Entergy Nuclear Operations, Inc.
Pilgrim Nuclear Power Station
600 Rocky Hill Road
Plymouth, MA 02360

Additional Information Concerning Revised Request for Authorization
under the Provision of 10 CFR 50.55a(a)(3)(i) for Modification of Core
Shroud Stabilizer Assemblies (TAC NO. MD4918)

LETTER NUMBER: 2.07.045

Additional Information In Support of Proposed Core Shroud Stabilizer Assembly Configuration

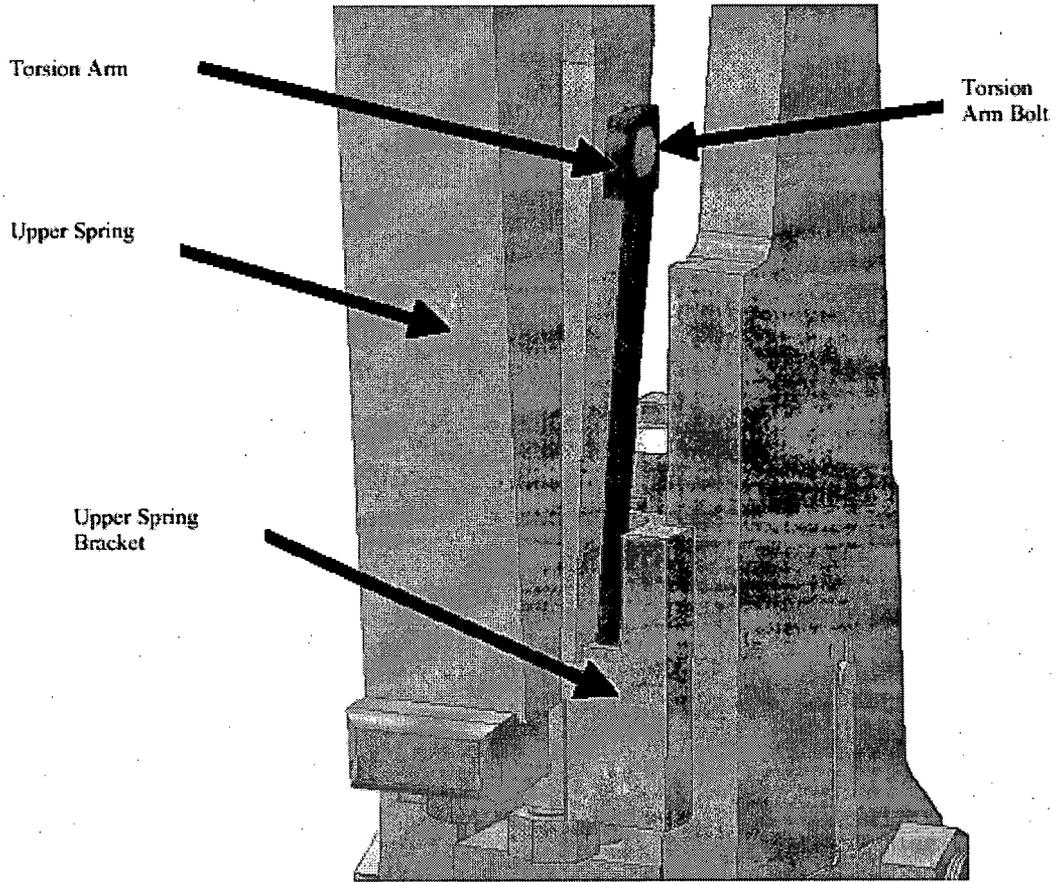
Provide justification for allowing operation for one cycle with flaws in X-750 components in tie rod upper supports (135° and 315° locations) and torsion arm bolt where access for examination is limited.

Using the model of the support, two cases were evaluated: (1) a semi-circular starting flaw located at the center of the support and (2) an elliptical starting flaw located at one edge. The two cases are considered to bound the crack growth behavior of all expected crack initiation locations given the starting flaw size assumptions. The center flaw provides the most conservative estimate of crack growth because the flaw can grow in both directions. The corner flaw gives the upper bound life assessment. The stress distribution observed in the upper support shows that flaw initiation is expected somewhat off center along the raised pads. This result does indicate that cracking would be visible on one of the two sides first. Using the assumed starting flaws, the Normal Water Chemistry (NWC) crack growth relationship given in BWRVIP-138 (BWR Vessel and Internals Project, Updated Jet Pump Beam Inspection and Flaw Evaluation Guidelines) was used to propagate the indication both in the length and depth direction. This flaw growth rate may be conservative due to Pilgrim's implementation of hydrogen water chemistry and noble metal chemistry.

The critical flaw size was calculated using the finite element model of the upper support. Multiple solutions were obtained using the FEM with through width flaws of progressively deeper dimensions. The elastic stress distribution through the vertical failure plane at the tip of these flaws was used to determine the applied force and moment on the remaining ligament. This was compared to the theoretical plastic collapse moment for a rectangular section. The allowable flaw size is defined as the flaw size at which the ASME required safety factors (3.0 for Level A/B and 1.5 for Level C/D) are just met. The allowable flaw size for the Pilgrim Upper Support used in this assessment was a 0.7" through width rectangular shaped flaw. The assessment of acceptability was based on the maximum depth of the elliptical shaped crack.

The results of the PROPLIFE calculations for the two different crack locations were then evaluated. The center indication with a starting size of 0.2 inches deep by 0.4 inches long was found to be acceptable after one cycle (17520 hours) of operation. Similarly, the corner indication of 0.2 inches deep by 0.4 inches long was also shown to be acceptable for one cycle. This corner flaw was predicted to grow more slowly than the

Figure 1

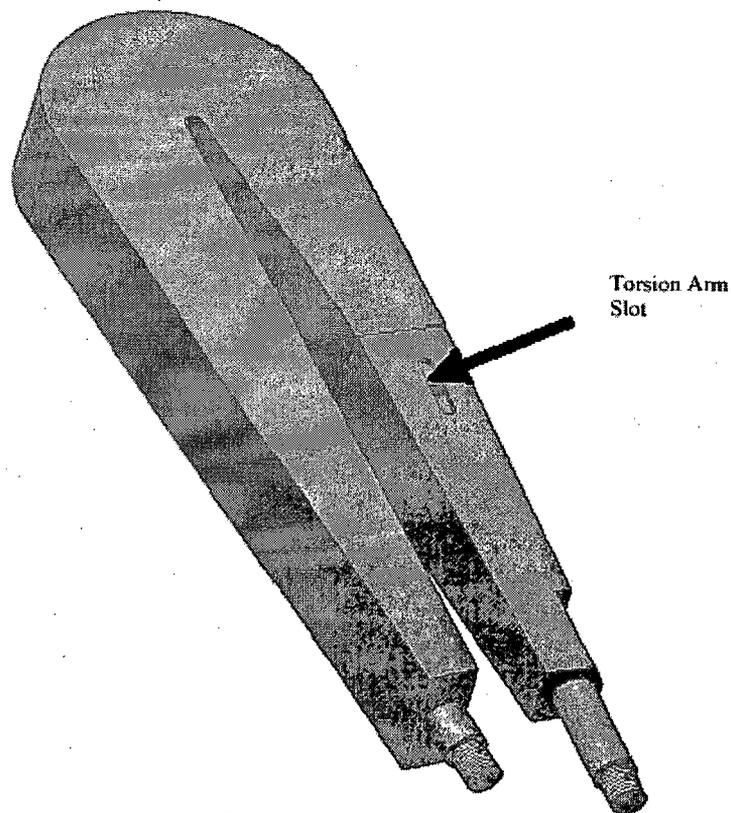
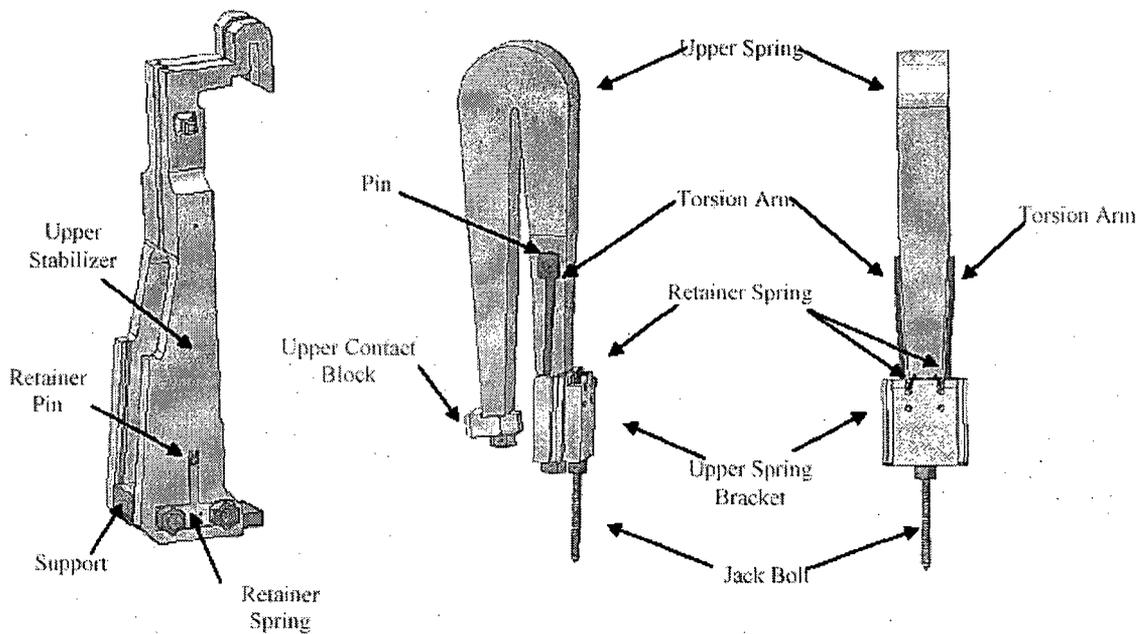
What is the maximum rotation considering the design and failure of the torsion arm bolt?

The torsion arm assembly and torsion arm clamp are shown in Figures 1, 2, 3, and 4.

The nominal rotation is 4.2°. Considering the tolerances, the maximum rotation is 5° in each direction
